INVITATION TO BID RESERVE AT HUDSON CROSSING PUBLIC IMPROVEMENTS– ADDENDUM #1
March 1, 2019

Engineering Plans
for
the Village of Oswego

Project No.:	SH0002
File Name:	51_SAN_P&P_HAR.dgn
Issue Date:	3/1/2019
Scale:	HORIZ: 1" = 20' VERT: 1" = 5'
Sheet Number	51

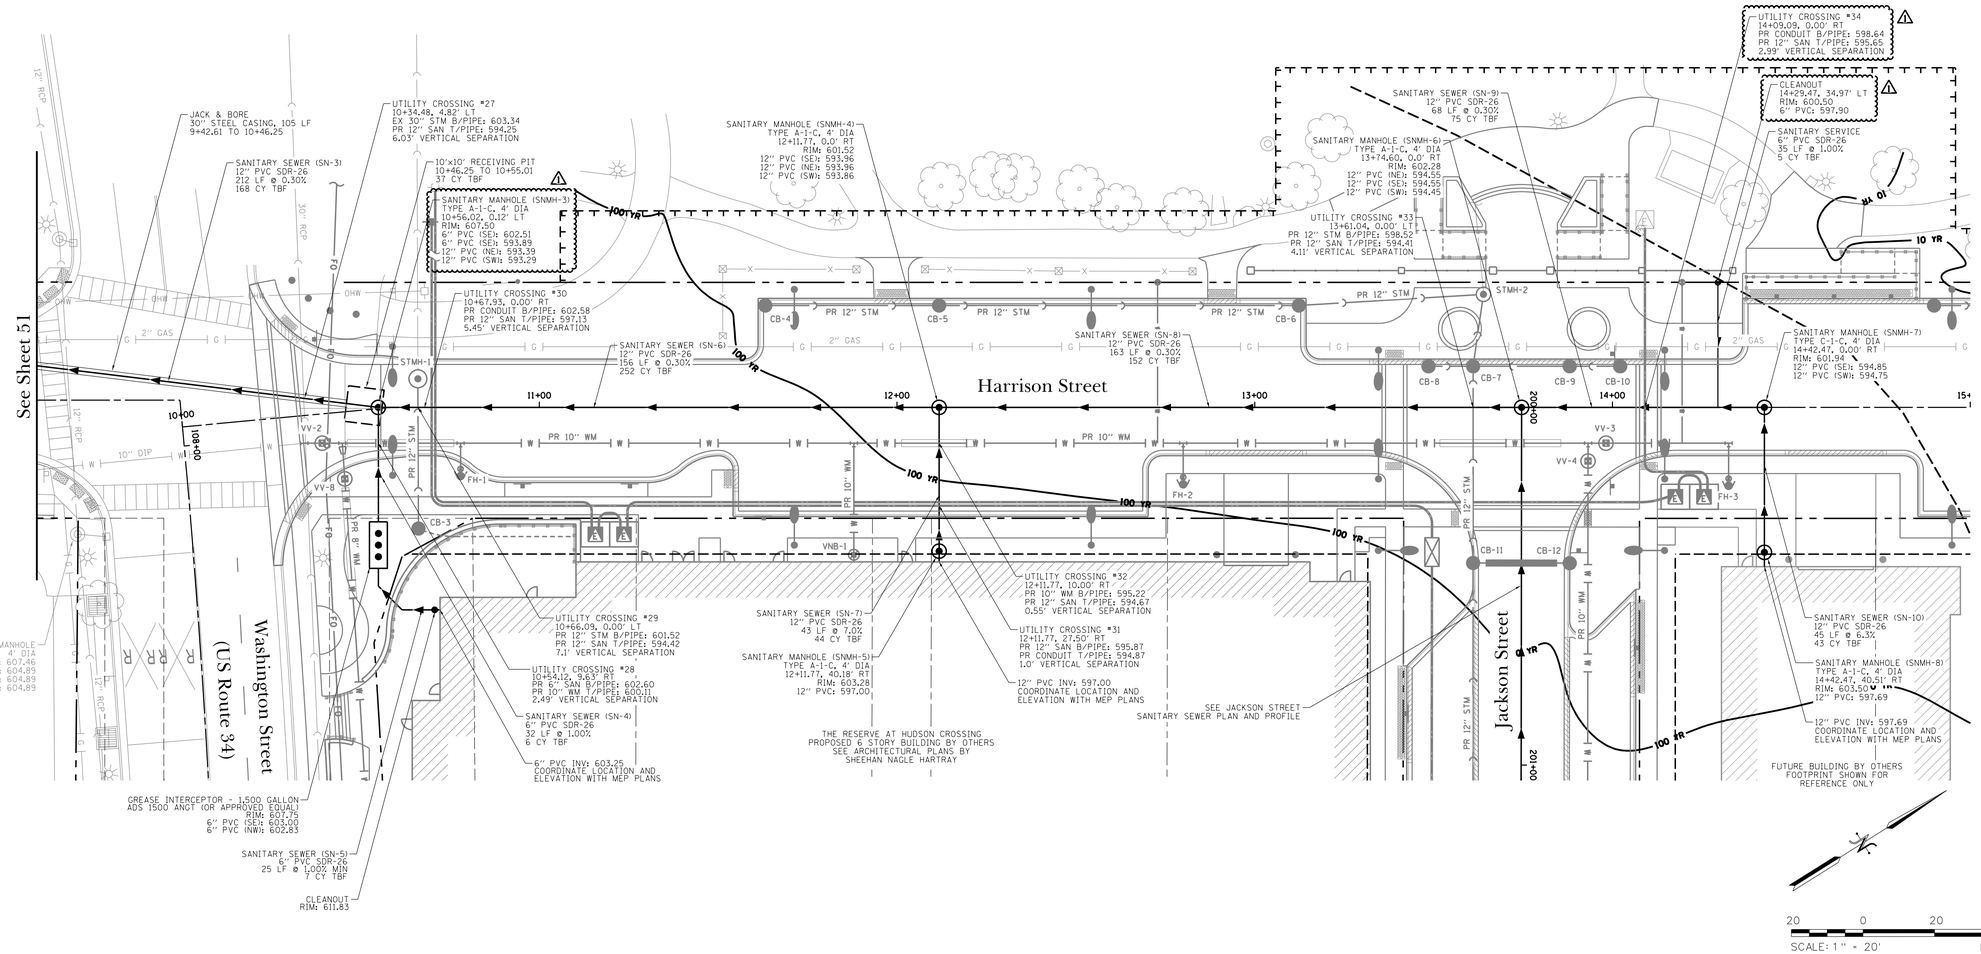
16. Sheet No. 51 – Sanitary Sewer Plan and Profile
    A. Revised approximate bedrock profile.
    B. Revised SNMH-2 to Sanitary DROP Manhole, Type A-1-C.
    C. Added notes re: monolithic drop connection required, and provided proposed drop invert elevation.

Project No.: SH0002
File Name: 52_SAN_P&P_HAR.dgn
Issue Date: 3/1/2019
Scale: HORIZ: 1" = 20' VERT: 1" = 5'
Sheet Number
52

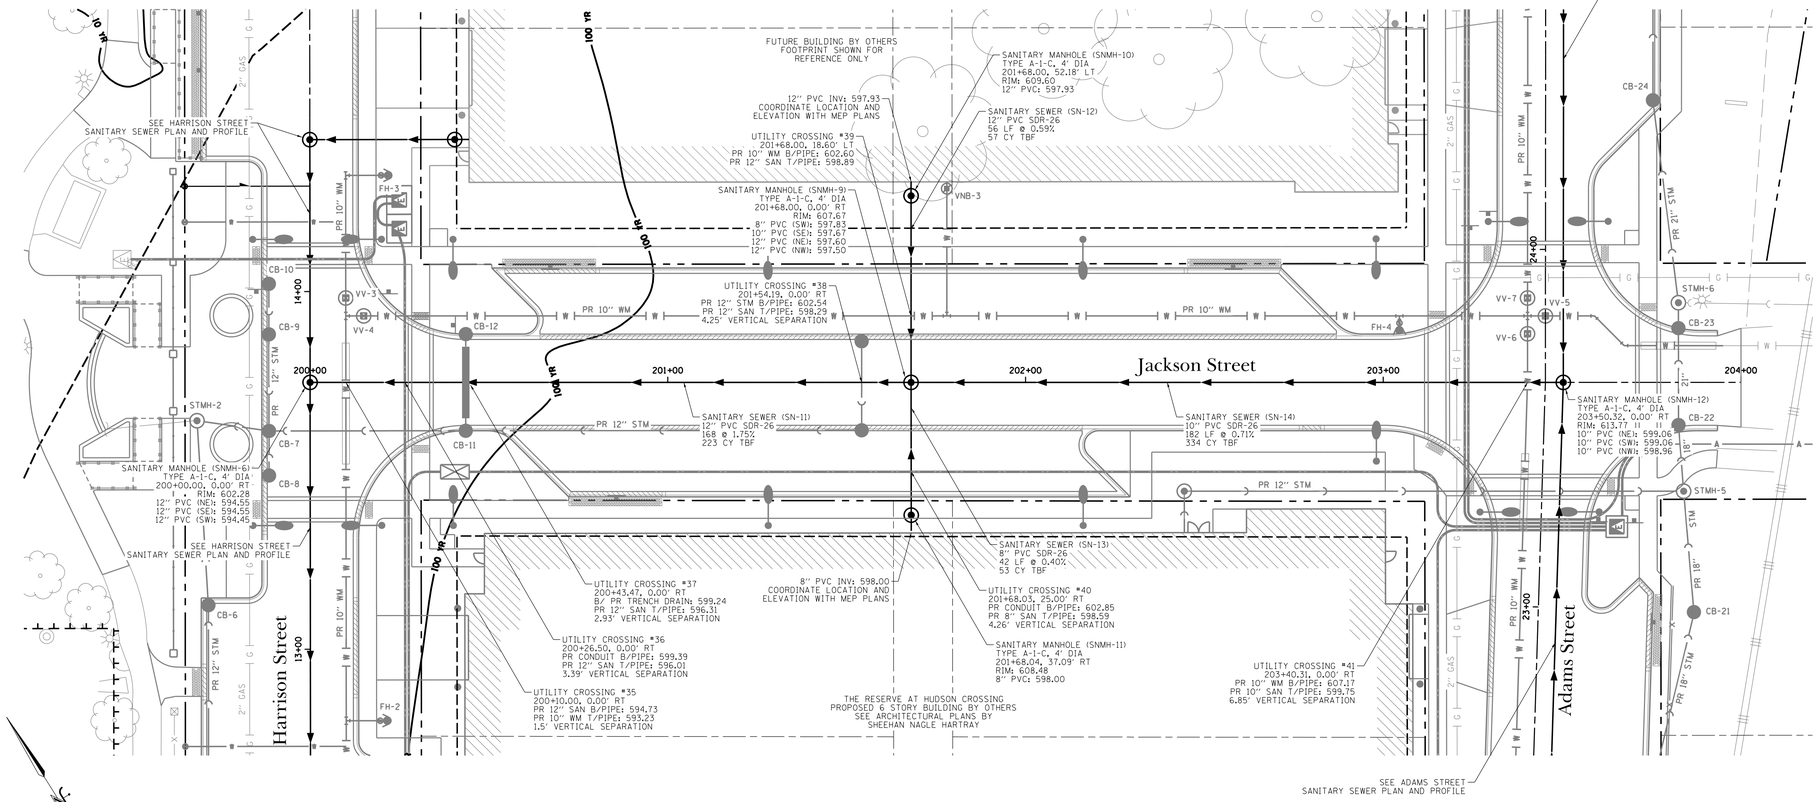
17. Sheet No. 52 – Sanitary Sewer Plan and Profile
    A. Revised approximate bedrock profile.
    B. Removed Legend showing proposed pipe insulation.
    C. Added notes re: 6" PVC (SE): 602.51 at SNMH-3 and installation of vertical 45-degree bends outside manhole to make connection to manhole at invert: 593.89.
    D. Revised Utility Crossing #34 per revision to underground electric location.
    E. Added rim elevation to proposed cleanout at 14+29.47, 34.97' LT.

Project No.:	SH0002
File Name:	57_WM_P&P_HAR.dgn
Issue Date:	3/1/2019
Scale:	HORIZ: 1" = 20' VERT: 1" = 5'
Sheet Number	57

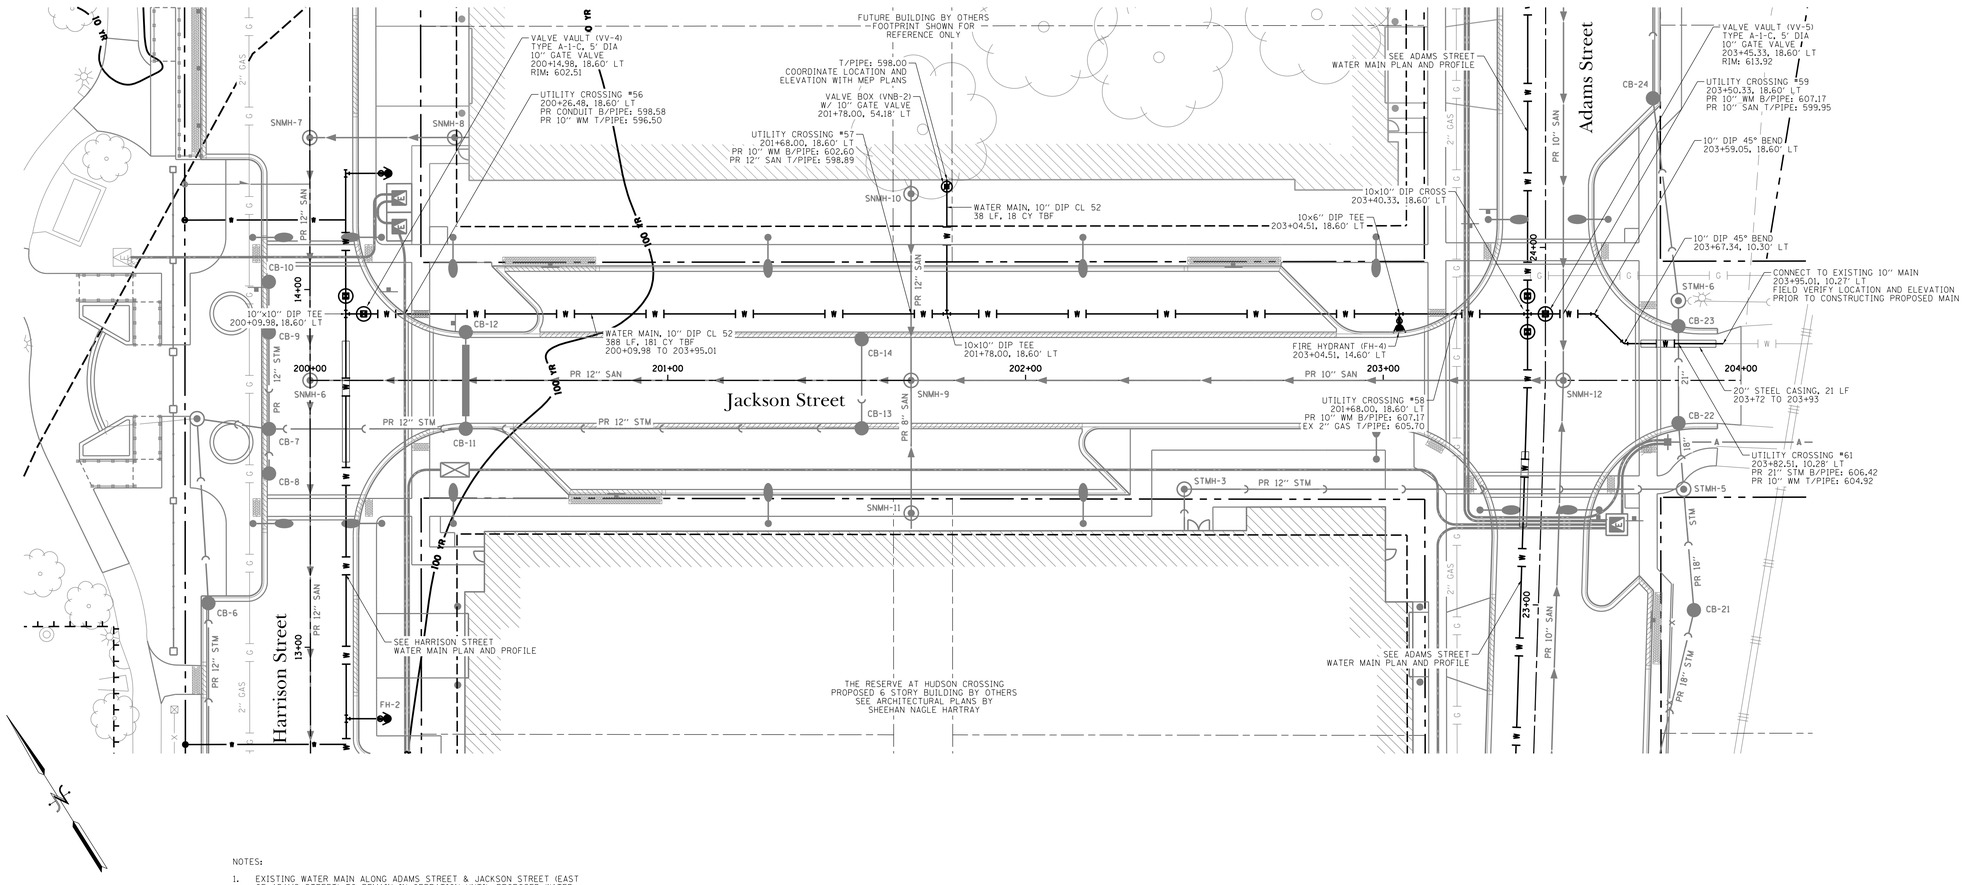
20. Sheet No. 57 – Water Main Plan and Profile
    A. Revised Utility Crossing #55 per revision to underground electric location.

Project No.: SH0002
File Name: 62_ELEC_HAR.dgn
Issue Date: 3/1/2019
Scale: 1" = 20'
Sheet Number
62

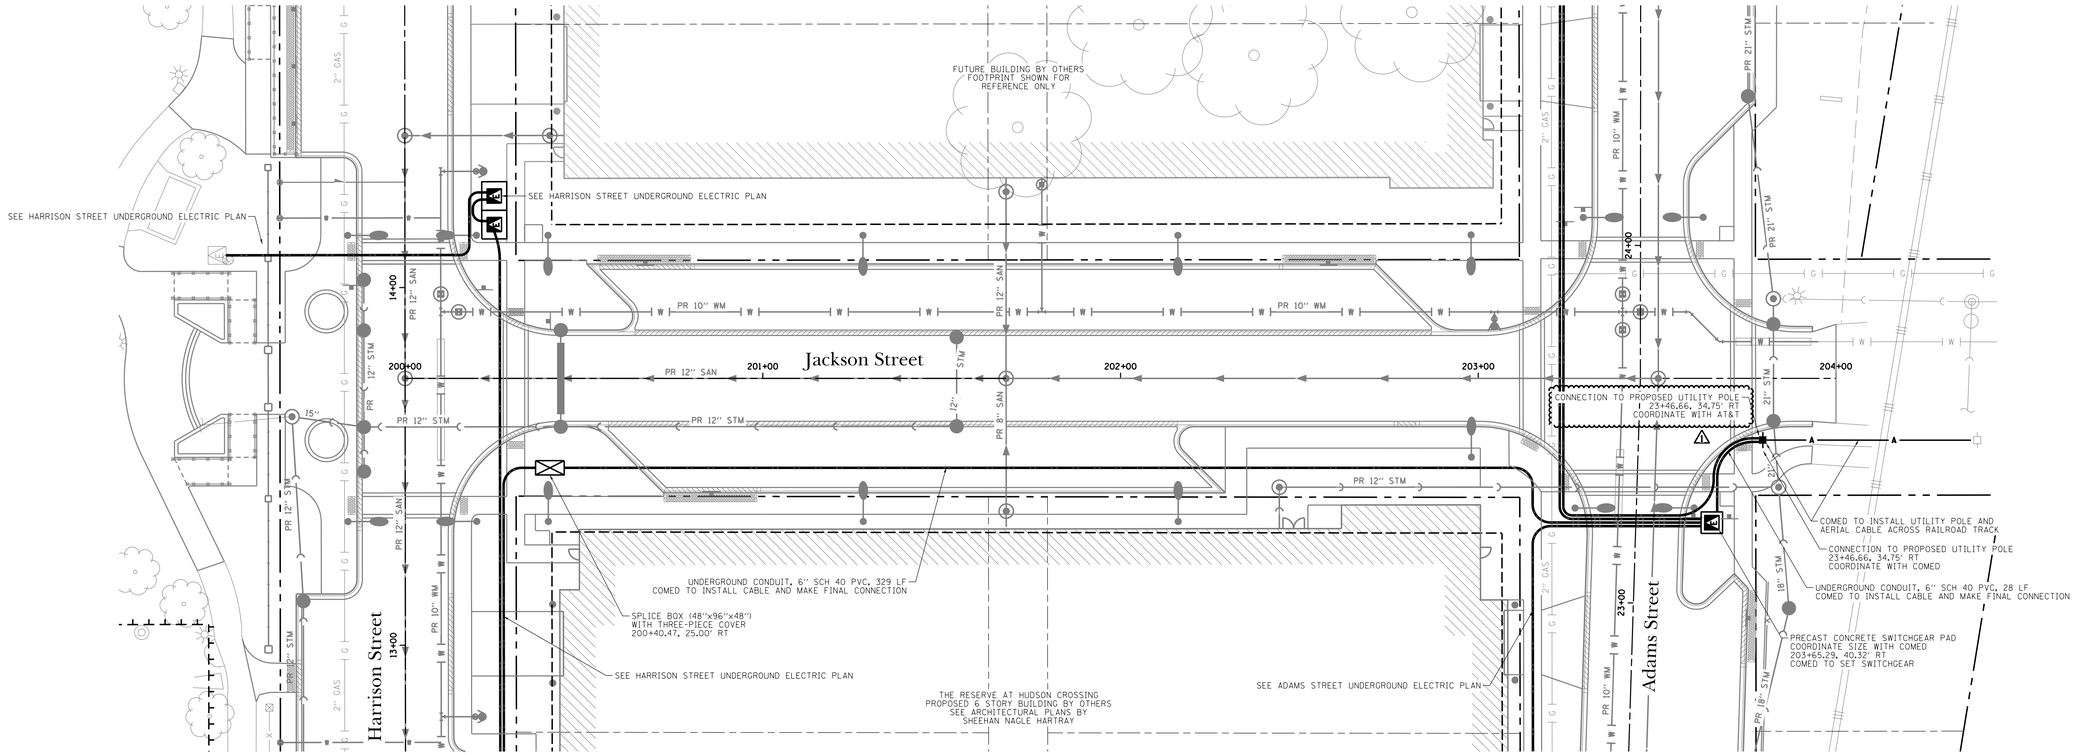
21. Sheet No. 62 – Underground Electrical Plan- Harrison Street
    A. Added proposed utility pole to be installed by Comed at 11+68.93, 74.13' LT.
    B. Underground Conduit, 6" SCH 40 PVC quantity revised from 346 LF to 388 LF.

C. Relocated Precast Concrete Transformer Pad from 11+20.09, 35.50' RT to 11+15.67, 35.50' RT.
    D. Added Precast Concrete Transformer Pad at 11+23.67, 35.50' RT.

E. Underground Conduit, 6" SCH 40 PVC quantity revised from 198 LF to 193 LF.
    F. Added Underground Conduit, 6" SCH 40 PVC (8 LF).
    G. Underground Conduit, 6" SCH 40 PVC quantity revised from 303 LF to 297 LF.

H. Added Precast Concrete Transformer Pad at 14+17.57, 25.00' RT.
    I. Relocated Precast Concrete Transformer Pad from 14+17.57, 23.49' RT TO 14+25.57, 25.00' RT.

J. Added Underground Conduit, 6" SCH 40 PVC (8 LF).
    K. Underground Conduit, 4" SCH 40 PVC quantity revised from 73 LF to 88 LF.
    L. 500 cu – 400 Amp Secondary Cable quantity revised from 85 LF to 100 LF.

Project No.: SH0002
File Name: 63_ELEC_JACK.dgn
Issue Date: 3/1/2019
Scale: 1" = 20'
Sheet Number
63

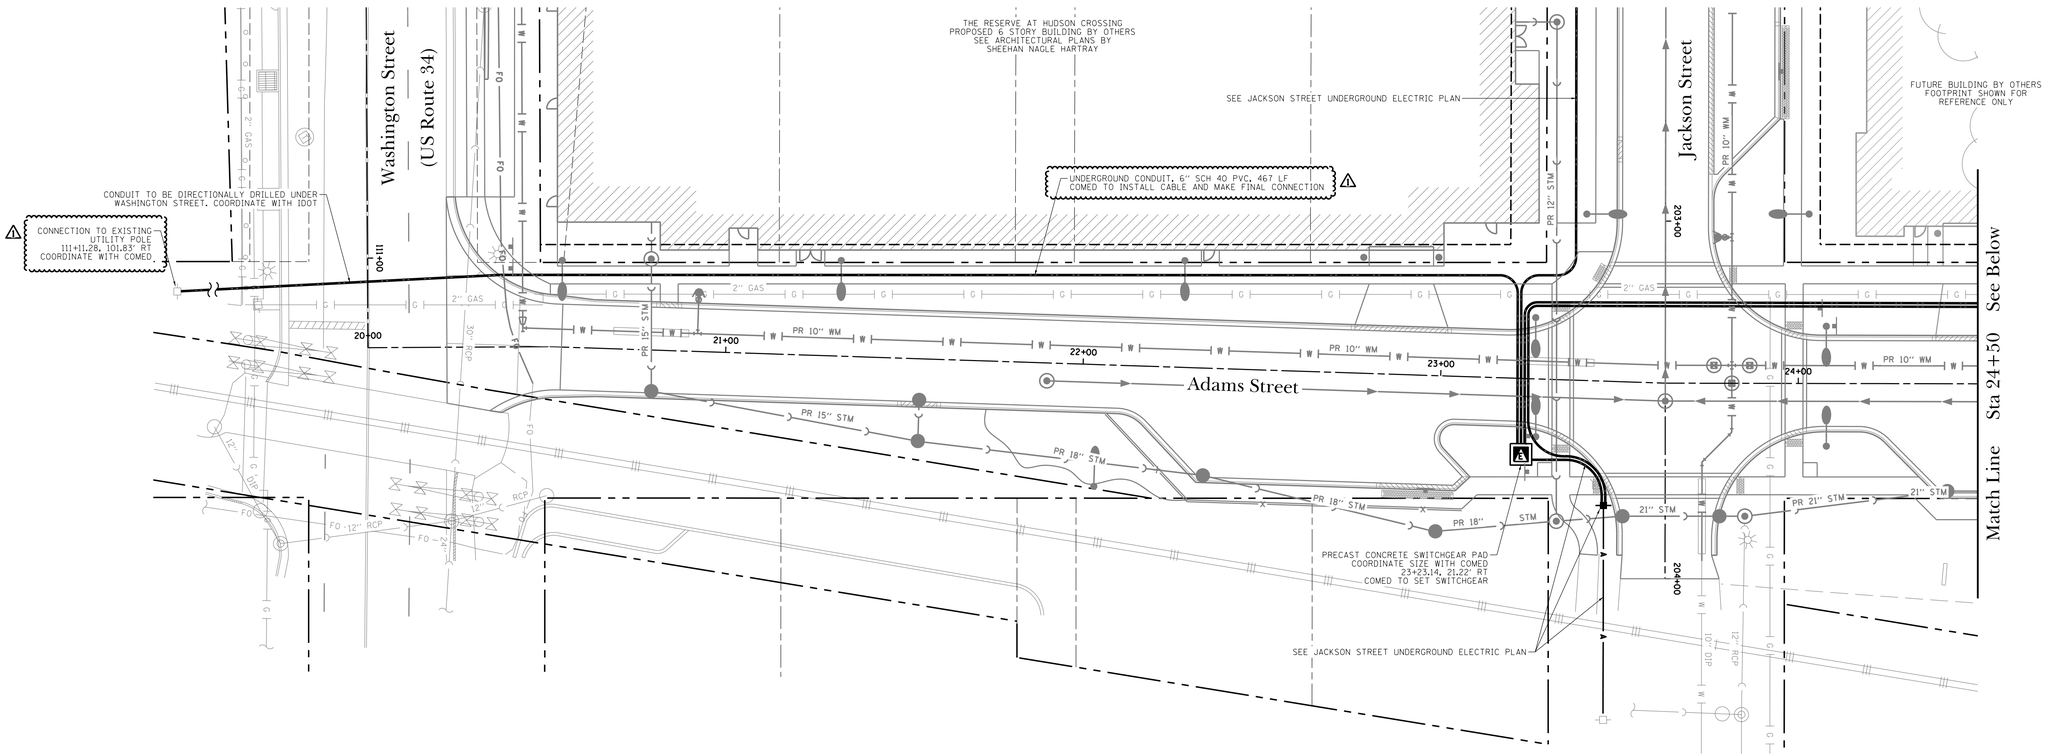
22. Sheet No. 63 – Underground Electrical Plan- Jackson Street
    A. Added Connection to Utility Pole at 23+46.6, 3475' RT for AT&T.
